Cedar Creek WWTP Improvements

Project No. 24022

ADDENDUM NO. 2 TO THE CONTRACT DOCUMENTS

CEDAR CREEK WWTP IMPROVEMENTS

SHEET NO. 05C301

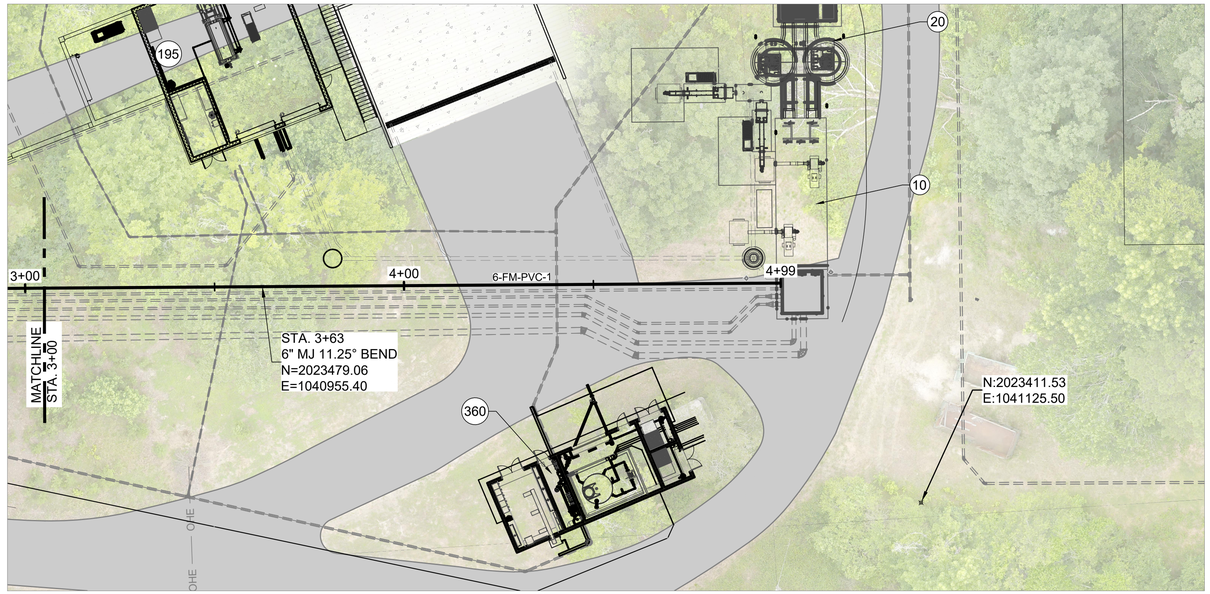
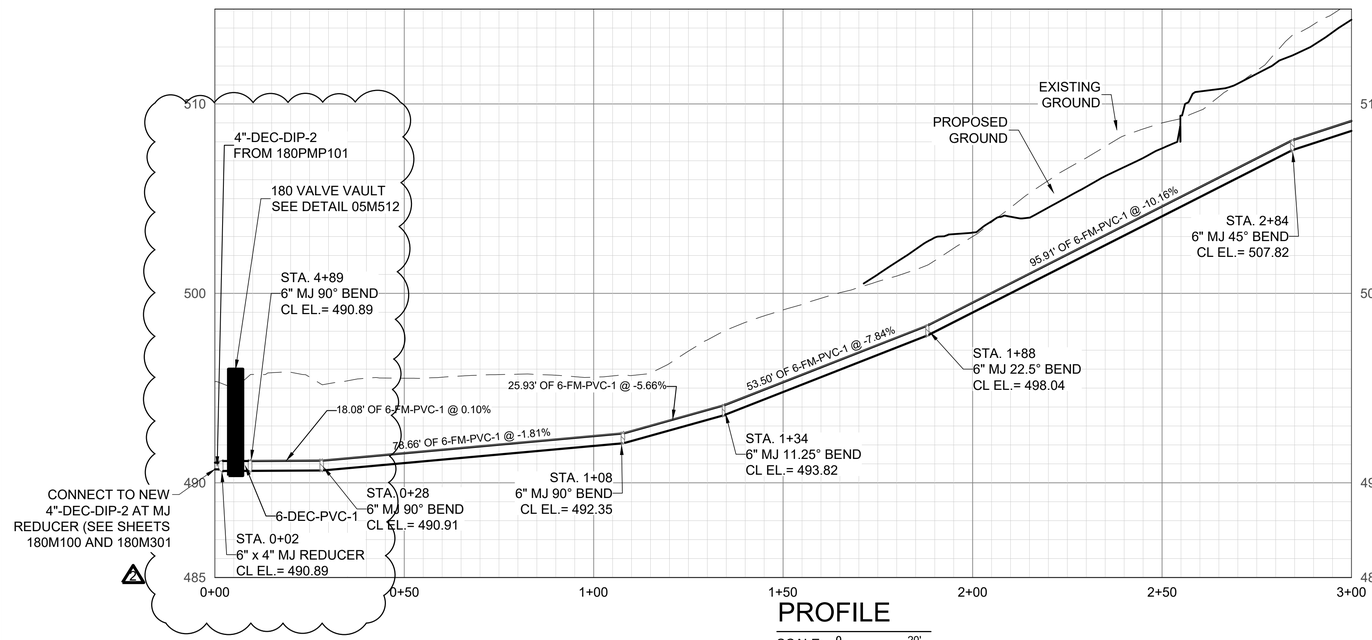
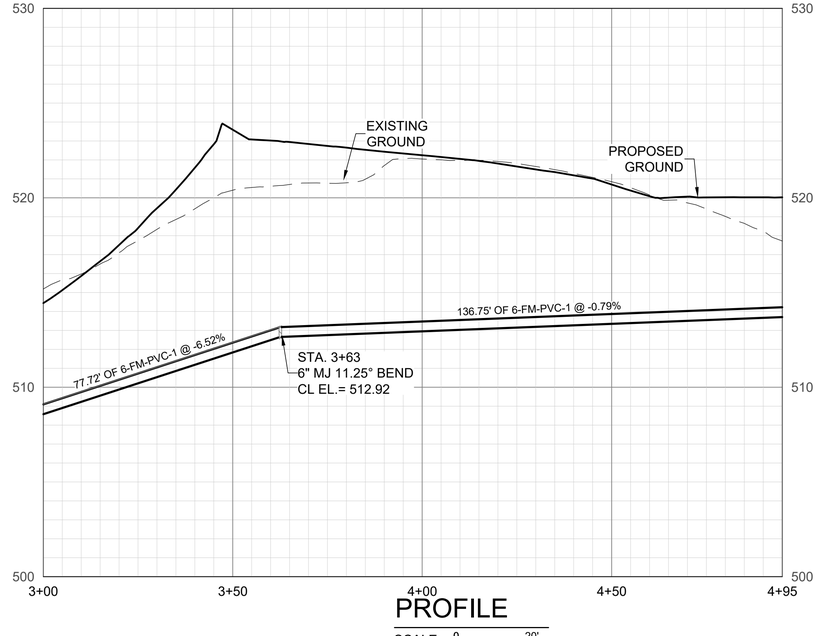
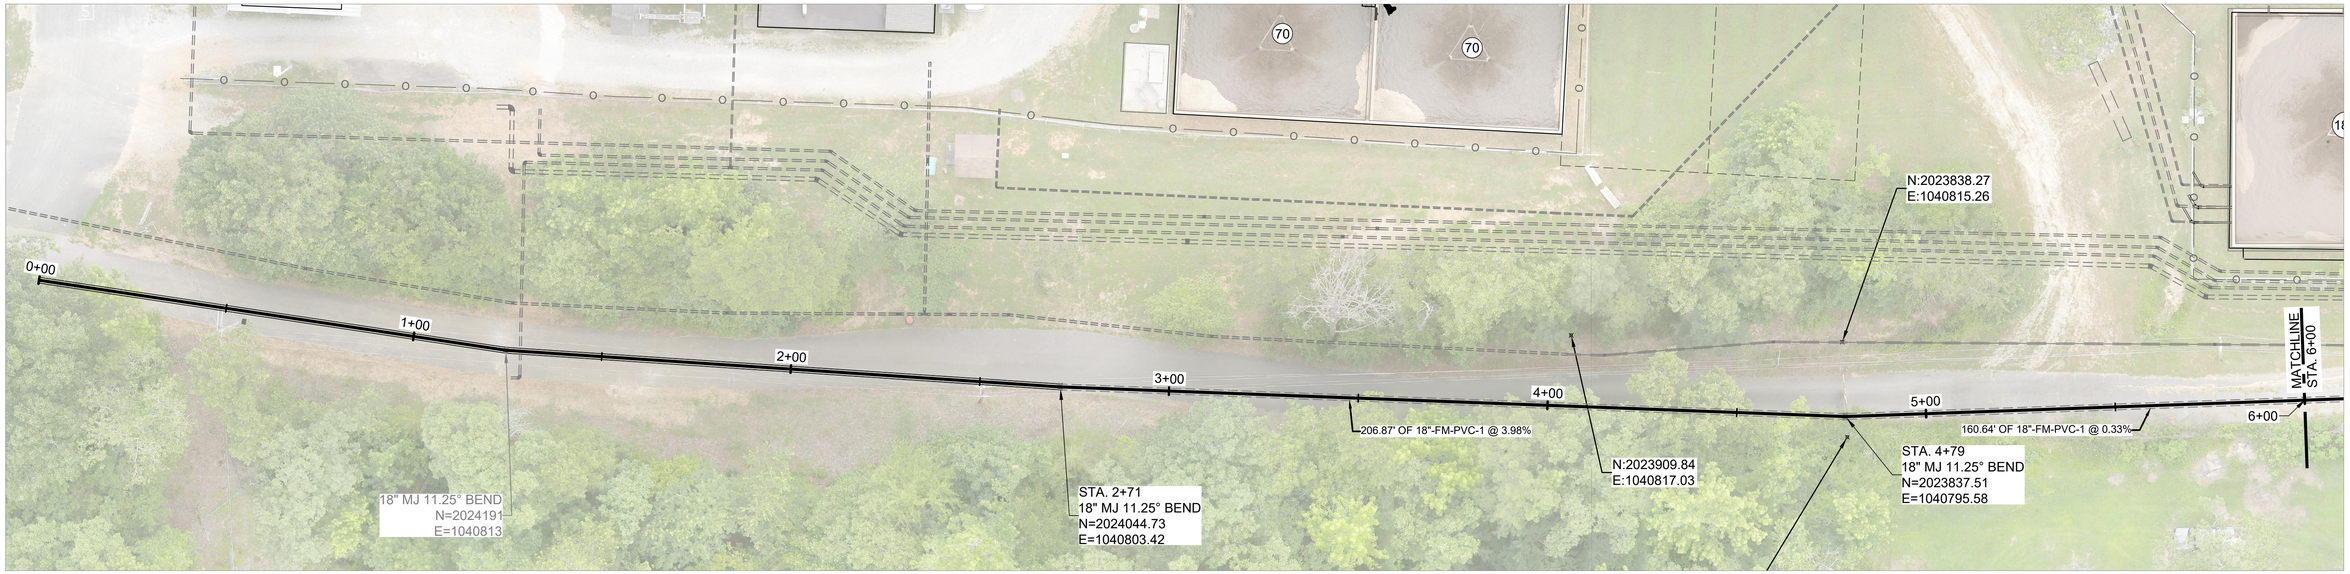
k. Delete Plan Sheets 05C301 and replace with Plan Sheets 05C301 Addendum No. 2.

REV. NO.	DATE	DRWN	CHKD	REMARKS
2	5/14/26	MAB	BNW	ADDED CLARIFICATION TO CONNECTION FROM MECHANICAL TO CIVIL

SHEET NO. 05C310

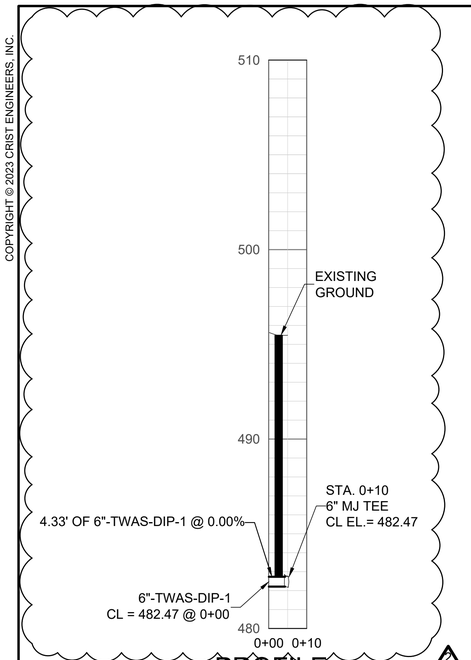
p. Delete Plan Sheets 05C310 and replace with Plan Sheets 05C310 Addendum No. 2.
q. Delete Plan Sheets 05C314 and replace with Plan Sheets 05C314 Addendum No. 2.
r. Delete Plan Sheets 05C316 and replace with Plan Sheets 05C316 Addendum No. 2.
s. Delete Plan Sheets 05C317 and replace with Plan Sheets 05C317 Addendum No. 2.
t. Delete Plan Sheets 05C318 and replace with Plan Sheets 05C318 Addendum No. 2.
u. Delete Plan Sheets 05C319 and replace with Plan Sheets 05C319 Addendum No. 2.
v. Delete Plan Sheets 05C320 and replace with Plan Sheets 05C320 Addendum No. 2.
w. Delete Plan Sheets 05C321 and replace with Plan Sheets 05C321 Addendum No. 2.

REV. NO.	DATE	DRWN	CHKD	REMARKS
2	5/13/26	MAB	BNW	DETAILED TIE IN AND UPDATED PROFILES

SHEET NO. 05C314

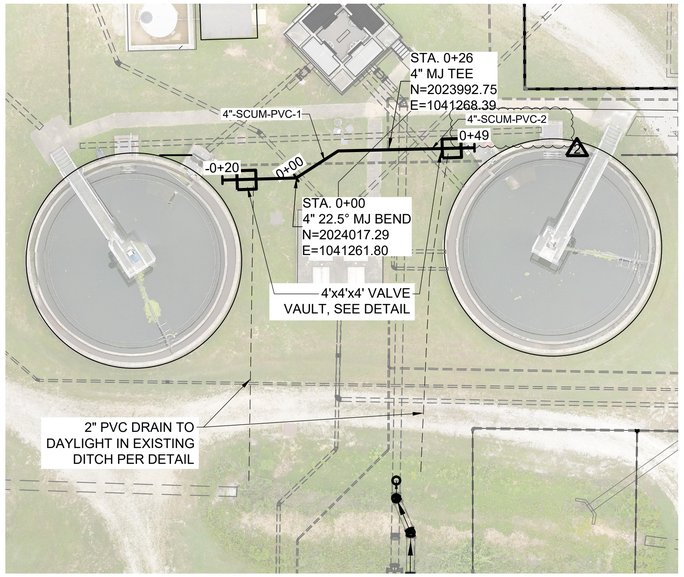
15	Drawing sheet 05C314 calls out valve 1”-AVRV-TWAS-2. I cannot locate it on the valve schedule. Should it be added to the valve schedule or is it mis-named on the drawings? It appears that perhaps it should be identified as 1”-AVRV-TWAS-1, which is on the schedule.	See Addendum No. 2.	Addendum 02

16	See drawing sheet 05C314. Should the 60” Vaults for 1”-AVRV-TWAS-2 and 4”-RD-TWAS-1 have a 36” diameter opening in their bases or should they be solid? There does not appear to be any 2” drainage PVC DWV under these MH’s. Should the 60” vault for the Rupture Disk have a flat top and vent similar to the AVRV vaults?	See Addendum No. 2. Rupture disc detail shown on Plan Sheet 05C505, Detail C.	Addendum 02
17	I cannot locate a spec or detail for process floor drains. Please provide.	Floor Drains provided may be in accordance with Section 221100.	Addendum 02
18	Please clarify the following by Addendum. The Rolling Stairs and Platforms shown on the Drawings (20 Series and 195 Series), do not appear to be sized per the models/sizing listed on page 2 of Section 055136. Based on the manufacturer’s data sheets attached, please clarify the model and size required for each of the five locations listed	Model numbers identified in Section 055136 shall control.	-

REV. NO.	DATE	DRWN	CHKD	REMARKS
2	5/15/26	MAB	BNW	IDENTIFIED 4"-SCUM-PVC-2 ON PLAN AND PROFILE FOR CLARIFICATION

JOB NO: 24022
SHEET NO: 195-S-102

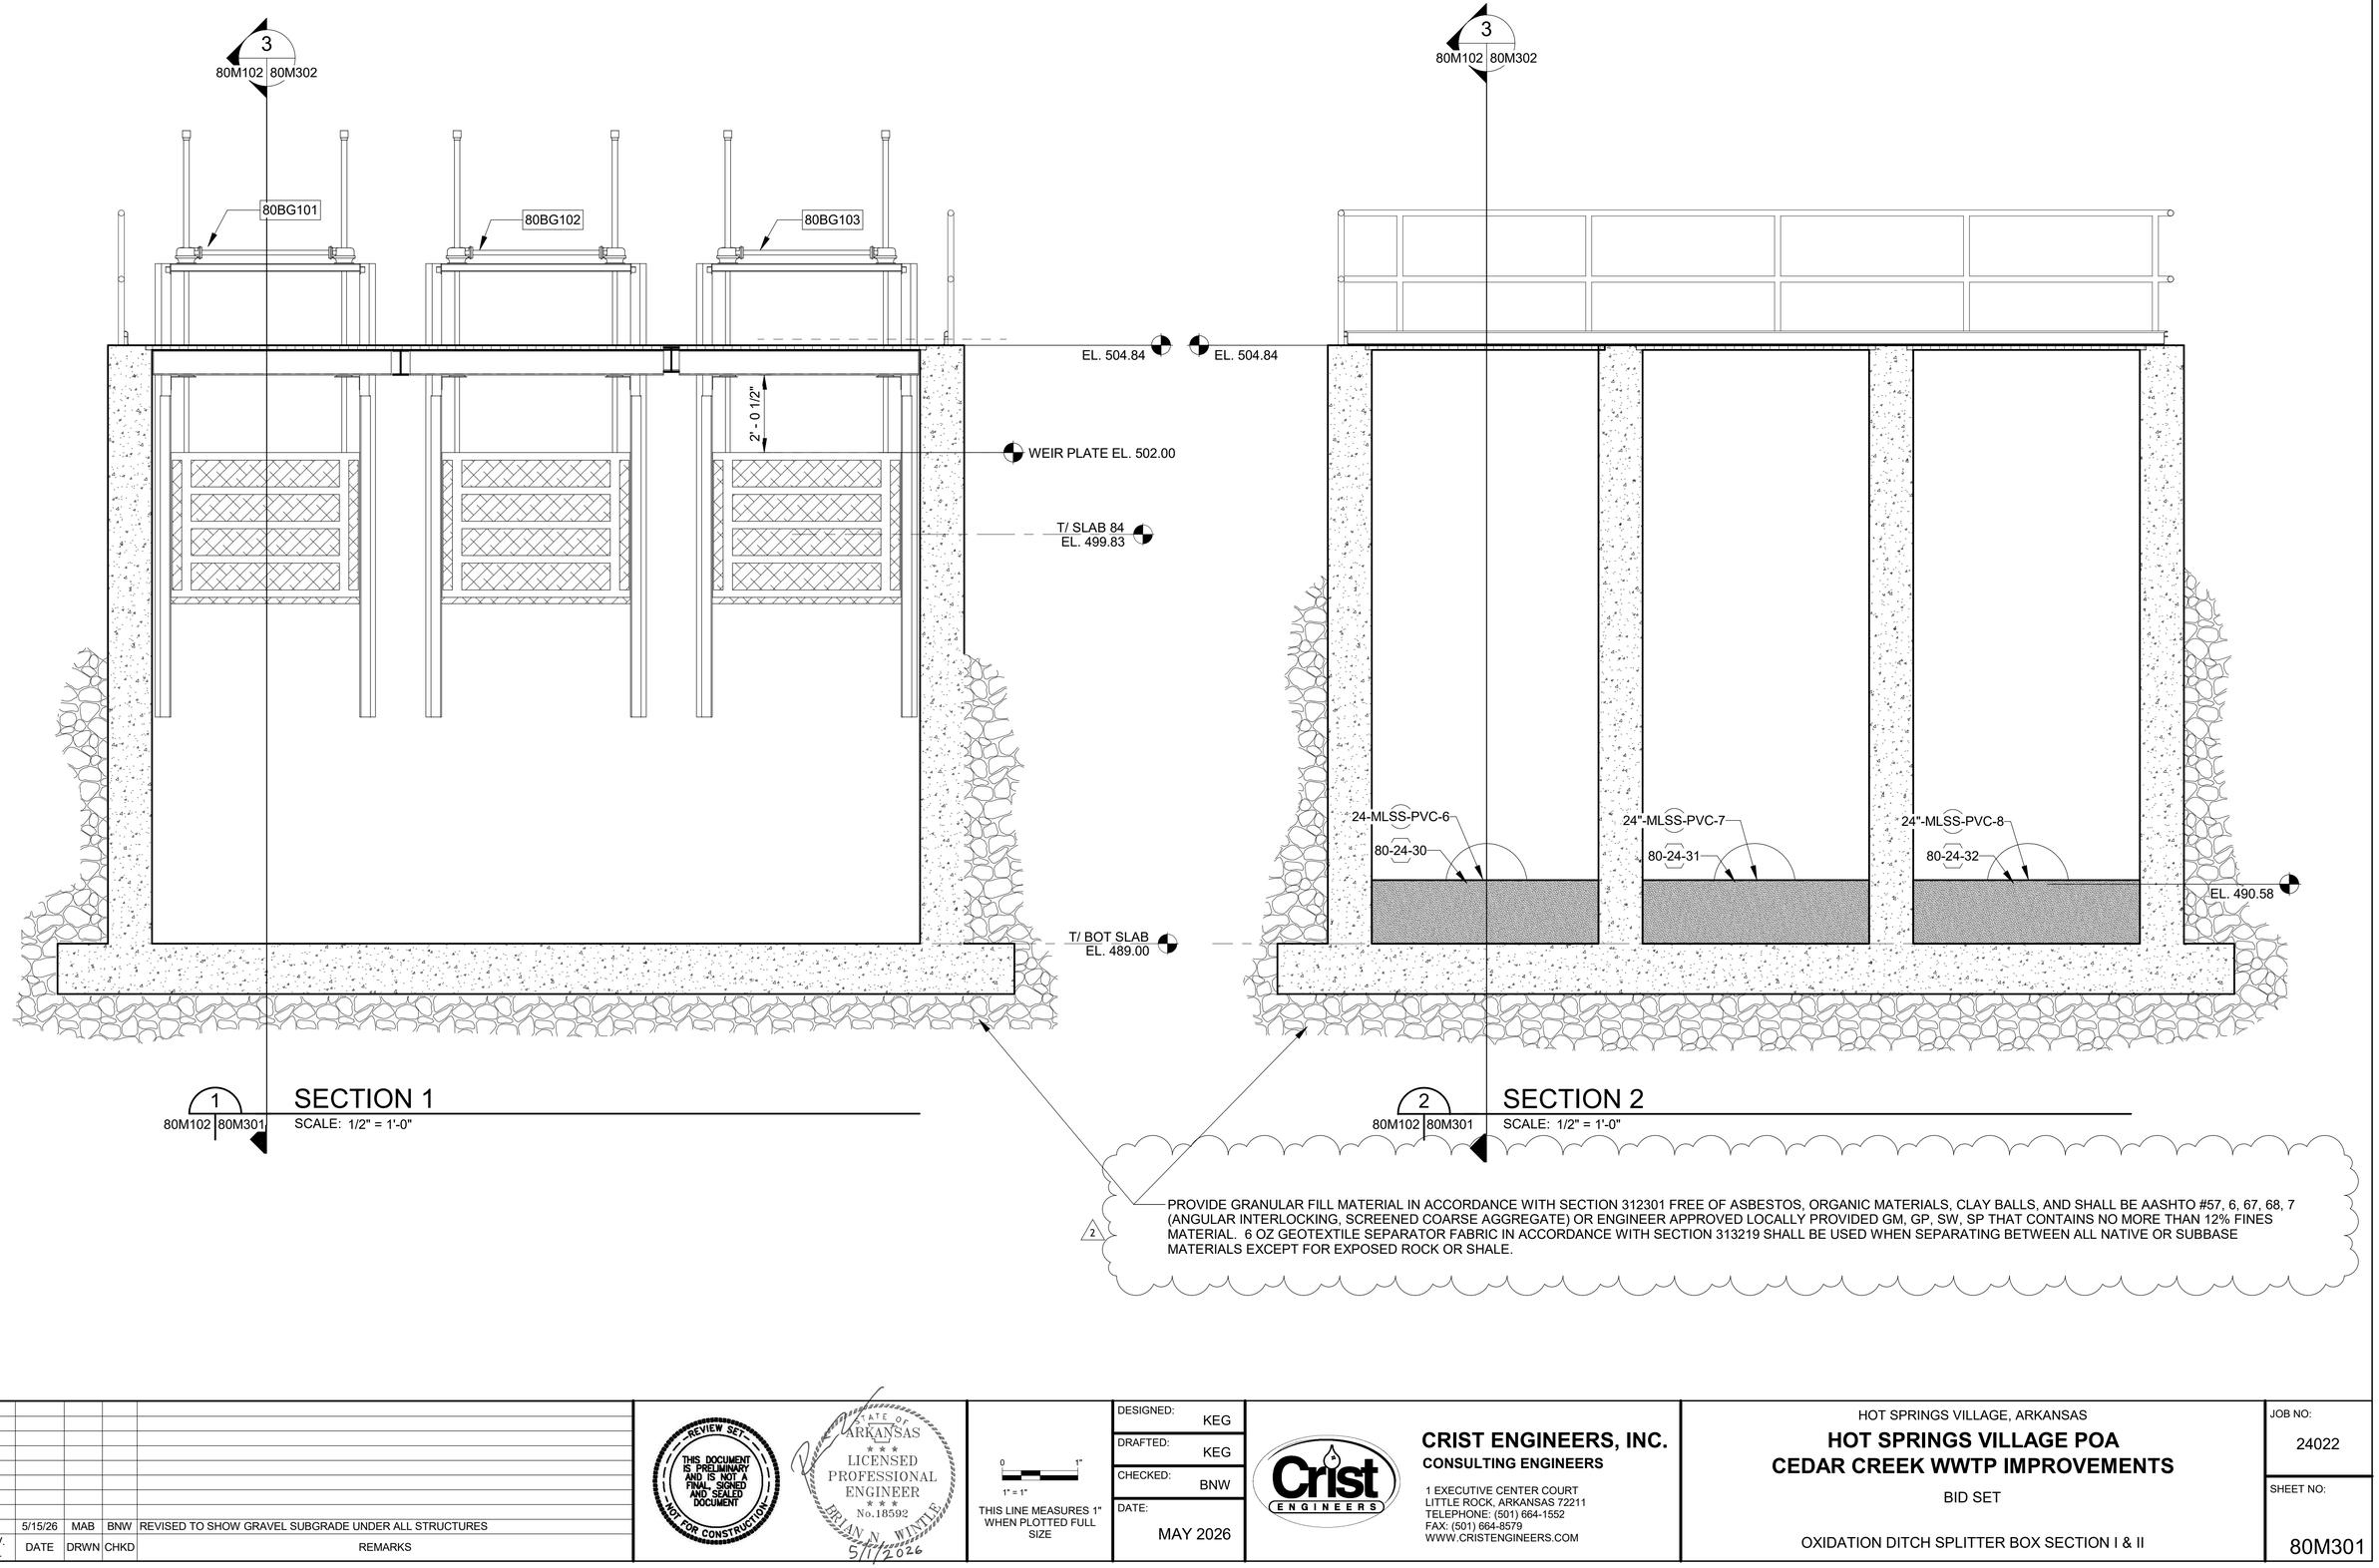
y. Delete Plan Sheets 195-S-102 and replace with Plan Sheets 195-S-102 Addendum No. 2.

REV. NO.	DATE	DRWN	CHKD	REMARKS
2	5/15/26	MAB	BNW	REVISED TO SHOW GRAVEL SUBGRADE UNDER ALL STRUCTURES

JOB NO: 24022
SHEET NO: 90M301

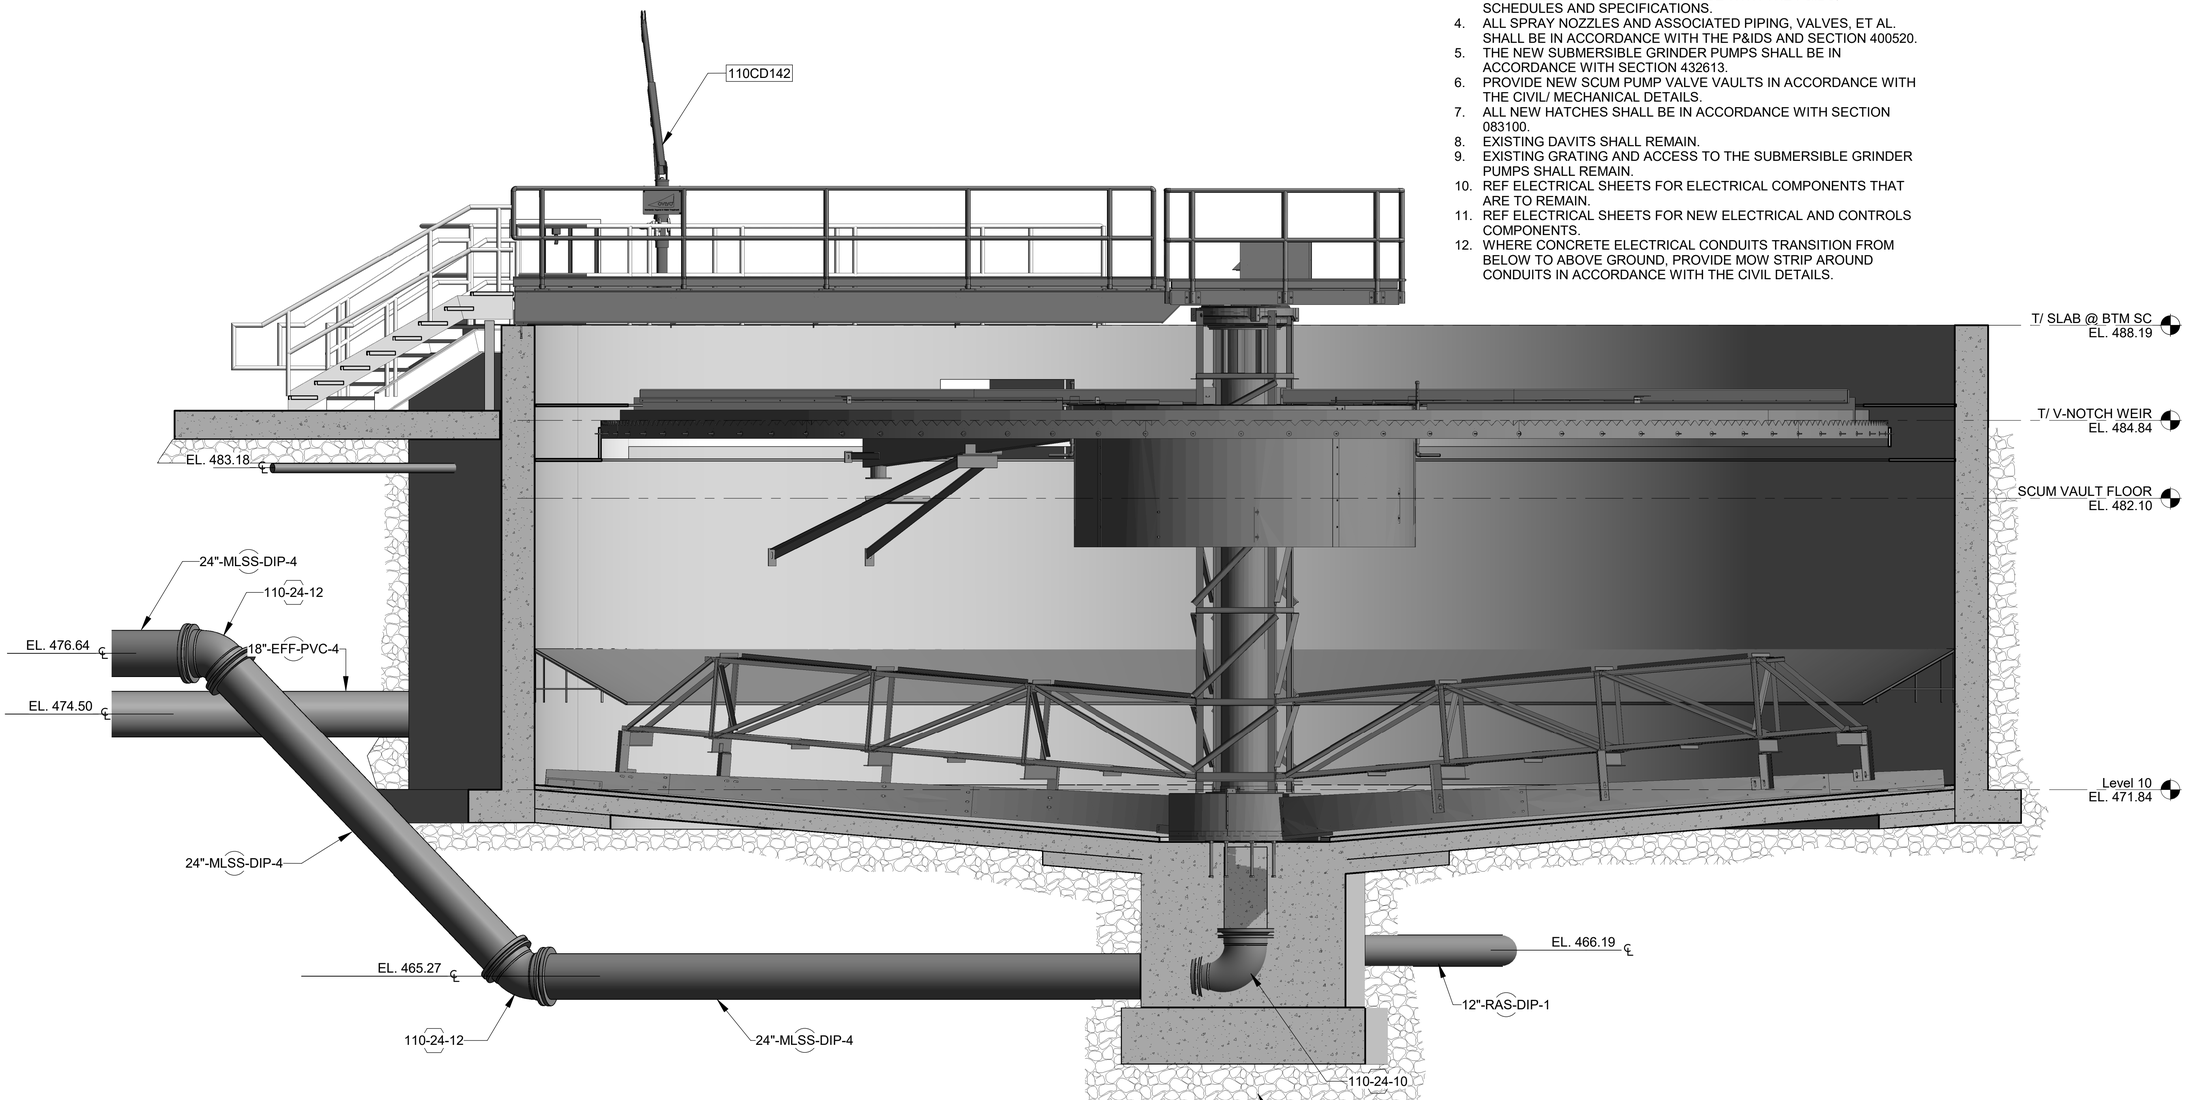
cc. Delete Plan Sheets 80M301 and replace with Plan Sheets 80M301 Addendum No. 2:
dd. Delete Plan Sheets 90M301 and replace with Plan Sheets 90M301 Addendum No. 2:
ee. Delete Plan Sheets 110M301 and replace with Plan Sheets 110M301 Addendum No. 2:
ff. Delete Plan Sheets 110M306 and replace with Plan Sheets 110M306 Addendum No. 2:
gg. Delete Plan Sheets 120M301 and replace with Plan Sheets 120M301 Addendum No. 2:
hh. Delete Plan Sheets 360M304 and replace with Plan Sheets 360M304 Addendum No. 2:

REV. NO.	DATE	DRWN	CHKD	REMARKS
2	5/15/26	MAB	BNW	REVISED TO SHOW GRAVEL SUBGRADE UNDER ALL STRUCTURES
